April 2018
FL762AB
NHTSA #18V-163
Transport Canada #2018-123

Subject: FCCC Motorhome Power Steering Hose Routing

Models Affected: Specific Freightliner Custom Chassis X-Line chassis equipped with Cummins ISL engines and manufactured January 21, 2010, through December 22, 2015.

Fig. 1, Power Steering Hose with P-Clip (body removed for clarity)

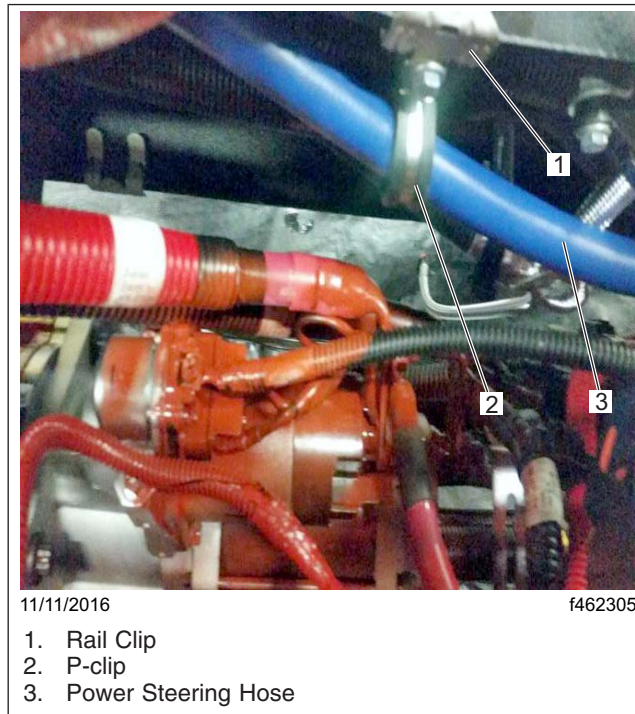
On certain motorhome chassis, the high pressure power steering hose may be routed with inadequate clearance between the hose and a power stud on the starter motor. This may cause the hose to chafe against the power stud on the starter, potentially leading to arcing and, in addition, may cause loss of fluid, short circuit, and melting. Electrical arcing in the presence of leaking power steering fluid can increase the risk of a fire.

- 6.1 If the power steering hose is held with a P-clip near the starter stud, no work is needed. See [Fig. 1](#). Clean a spot on the base label (Form WAR259). Write the recall number, FL762, on a completion sticker (Form WAR260), and attach it to the base label.

1. Install a rail clip on the top flange of the frame rail, just above the starter.
2. Using a P-clip, bolt, nut, and washer, secure the power steering hose on the rail clip. See [Fig. 1](#). Tighten the nut 72 lbf-in (813 N-cm).
3. For additional security, install tie bands around the hose to the harness near the frame rail within 18 inches (46 cm) of the P-clip.
4. Clean a spot on the base label (Form WAR259). Write the recall number, FL762, on a completion sticker (Form WAR260), and attach it to the base label.
